MASTER LIFT STATION 12A IMPROVEMENTS MANATEE COUNTY, FL.

PROJECT NO. 0019706-5001200

As-Builts

LEGEND / NOTES & SITE PLAN
MANATEE COUNTY LIFT STATION - 12A SANITARY SEWERAGE PROJECT

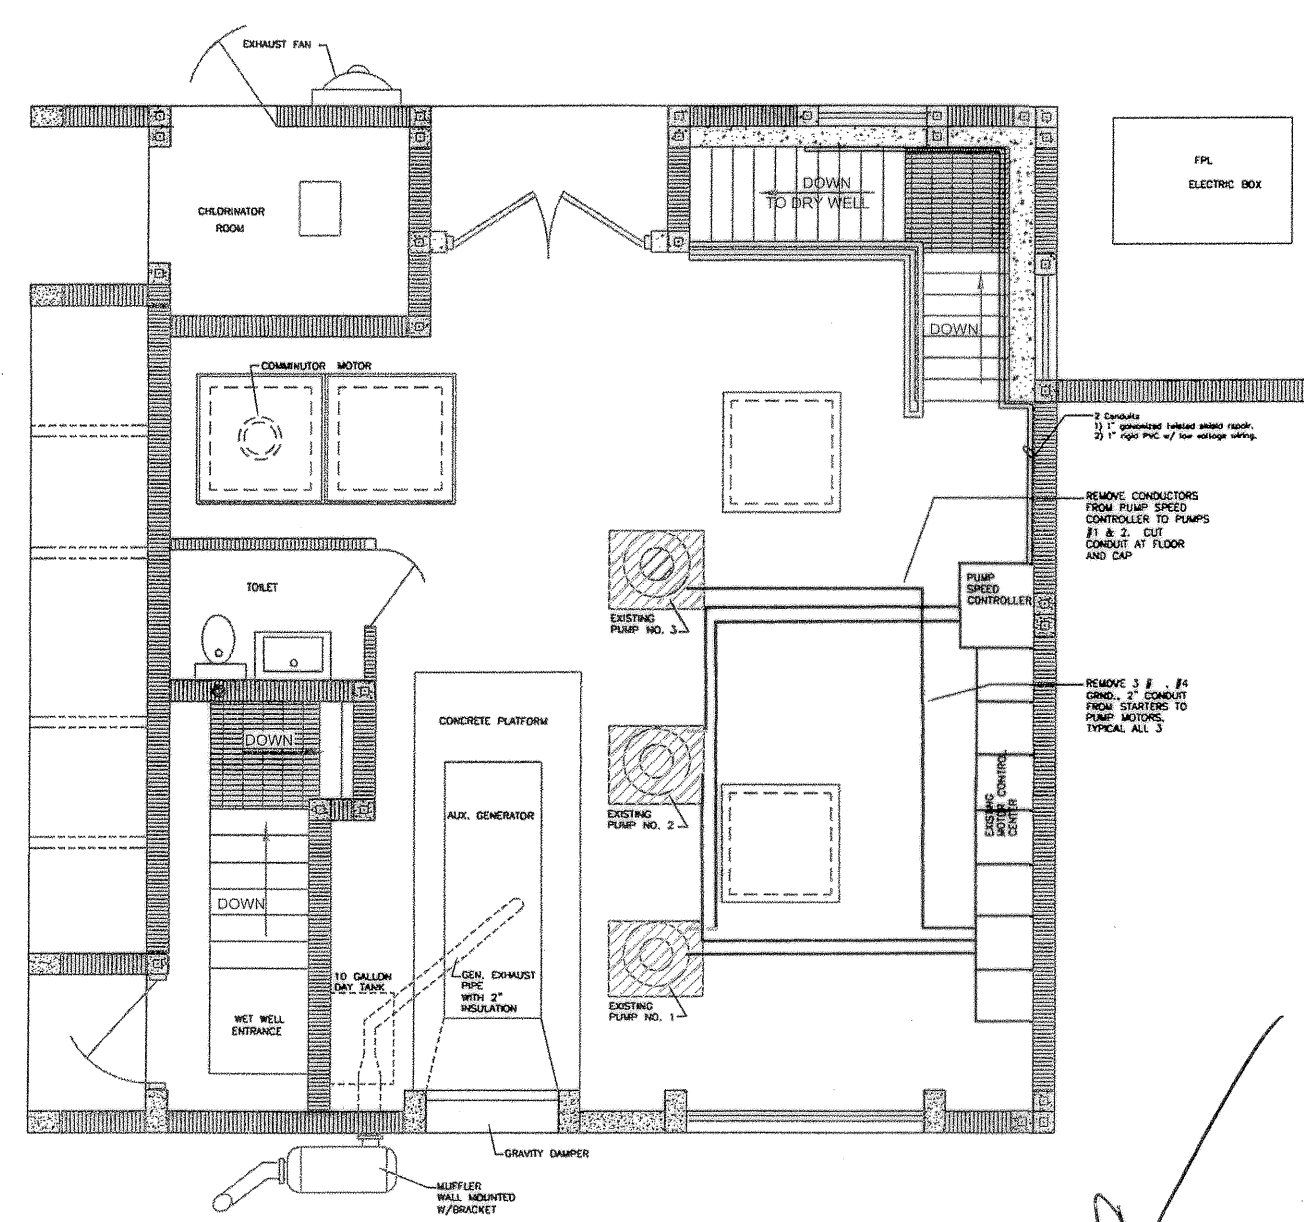
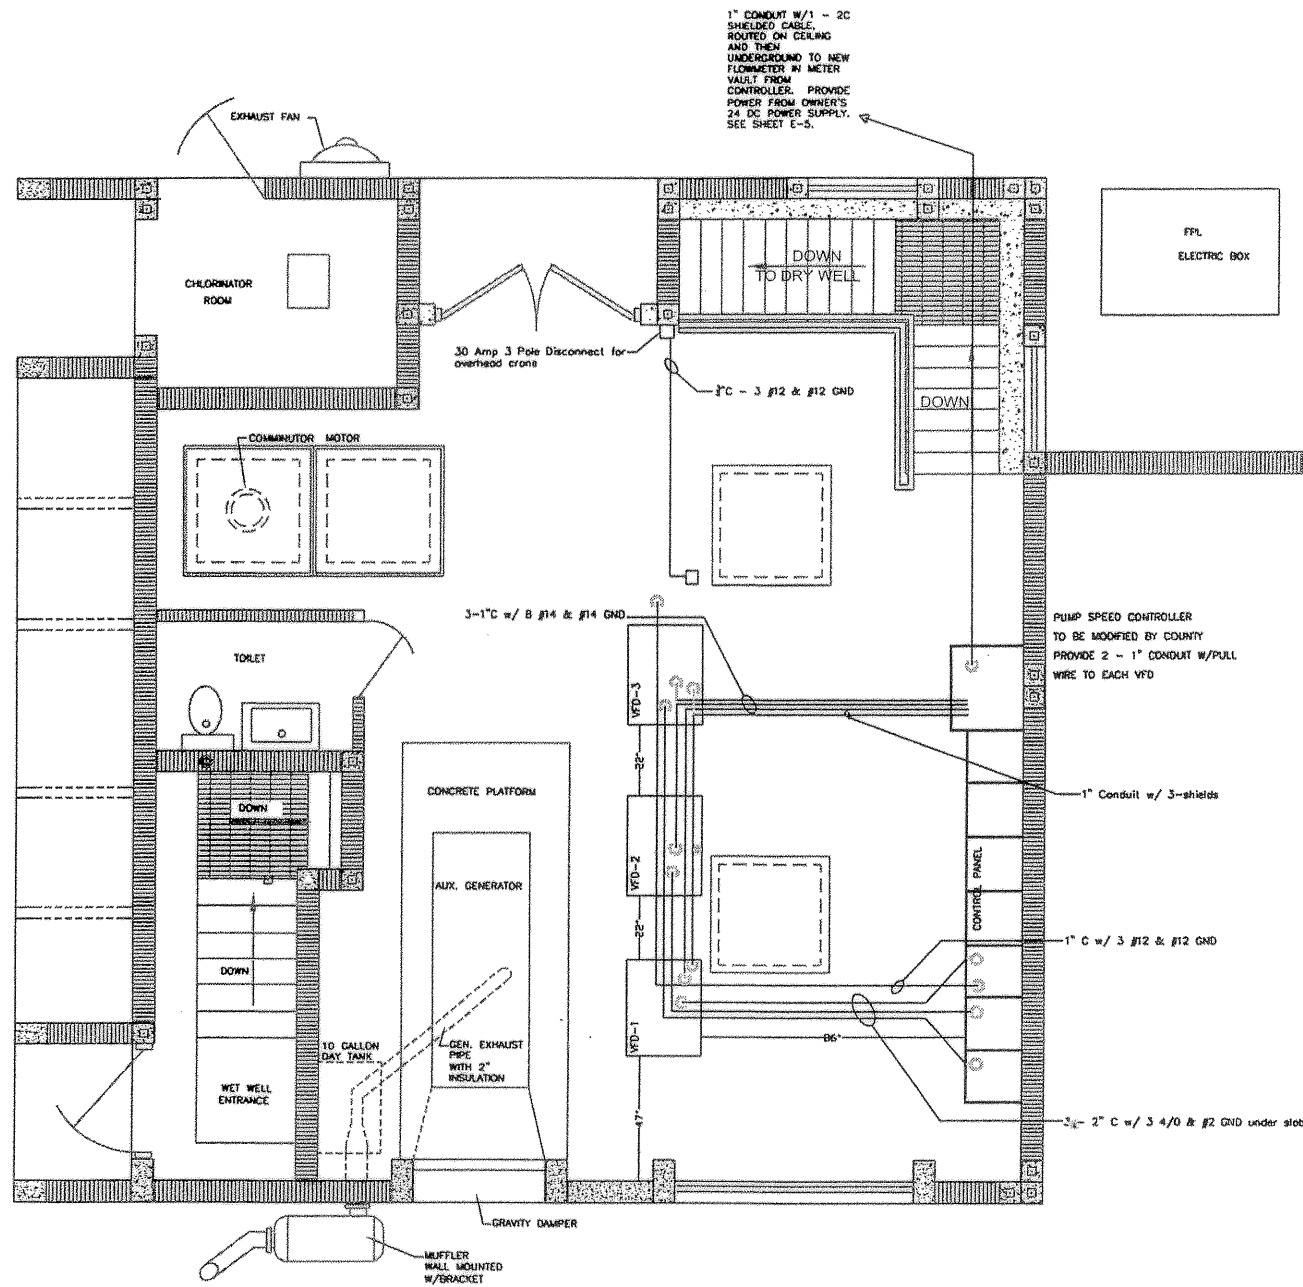
W.D. Camp, Manager, Vista Systems
According to the notes, all pump cables at 30A were run to the correct conduit without a problem. There are 2 non-conductive cases for this purpose.
